Appendix 1 – Camp Reserve Master Plan (2020)

Council endorsed master plan

September 2020

CAMP RESERVE, Castlemaine.

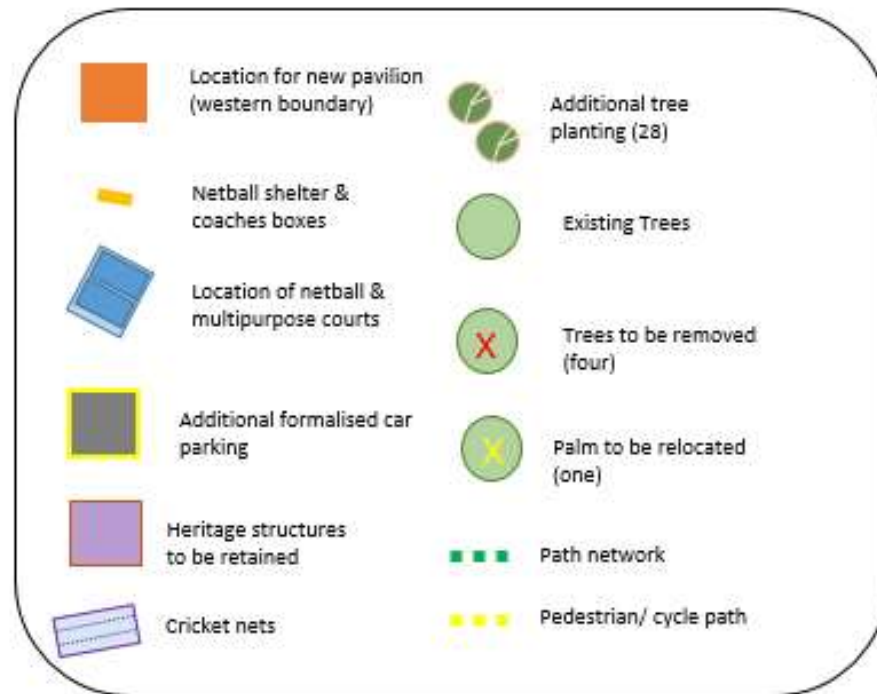
Item	Description
1.	That the pavilion be relocated to the western flank of the reserve
2.	The design of the pavilion should include an activated street frontage to Gingell Street and an architectural consultancy with demonstrated experience working with a heritage context be engaged to design the pavilion.

3.	That the oval length is to be retained, with the shape of the playing surface to be reviewed.
4.	That the netball and multipurpose courts be located at the southern end of the reserve and that appropriate amenity and shelter is provided. i.e. clearly defined path connection to and from the pavilion, a drinking fountain, bench seats, coaches boxes and spectator viewing shelter be provided.

5.	An instruction be added to the master plan to explore opportunities for a hit up wall to be incorporated into the netball court and multipurpose court area.

6.	Officers recommend that lighting of the netball and multipurpose court be restricted and only permitted until 9:30pm.
7.	Officers recommend that as part of Council's governance processes', hire agreements be developed and administered to clubs and groups who use the pavilion requiring them to adhere to noise restrictions.

8.	That a circulation pathway plan be prepared specifically to show the required space and movement around the Reserve for the Agricultural Show events and essential services.

9.	A proposed package of works for the Agricultural Show Pavilion be developed.
10.	That a tree management plan for the Reserve be prepared prior to removal of mature and historic trees.

11.	Provision be made for the replacement of the Agricultural Show office and ticket box if it is demolished.
12.	Officers recommend that the two Eucalyptus Camaldulensis trees continue to be monitored, managed and protected for as long as practicable.

13.	The draft master plan be amended to include the incorporation of additional trees and an instruction added with regards to ensuring appropriate tree species selection. Consideration of appropriate tree varieties will be made in detailed landscape design phase.

14.	Officers recommend the provision of circa 60 additional, 90 degree formalized car parking spaces be provided within the reserve and in addition, spectator structures at key locations also be included in the revised master plan.

15.	The shared path along the eastern boundary of the reserve should be provided at a minimum of 2.5m wide, desirably at a width of 3 meters.
16.	The proposed footpath network within the Reserve should be a minimum of 1.5m wide in all locations, however typically wider (2 meters) where adjacent to the oval.

17.	In addition to further encouraging bike riding to and from the reserve, officers recommend providing bicycle hoops at the pavilion, the netball courts and the agricultural pavilion.

18.	An instruction be added to the master plan to include strategically placed seating. Final location to be subject to detailed design.
19.	An instruction be added to the master plan to include interpretive signage acknowledging Aboriginal Cultural Heritage and stories in consultation with traditional owners.

20.	An instruction be added to the master plan with regards to ensuring further consultation is undertaken at detailed design stage for major elements within the Reserve i.e. the pavilion design, agricultural pavilion, and netball and multipurpose court design.
